SP4550519DB STRUCTUERS FOUNDATIONS (DESIGN BUILD) COMMENTS FROM INTERNAL/INDUSTRY REVIEW Cheryl Hudson (850) 414-5332 <u>Cheryl.Hudson@dot.state.fl.us</u>

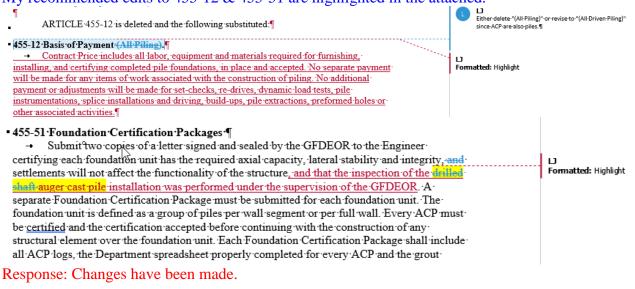
To avoid conflict (if that's possible) should we delete reference to EDC records and just say "all supplemental...."

Response: We don't think so. We do not have any issues to that sentence as it is currently. No changes made.
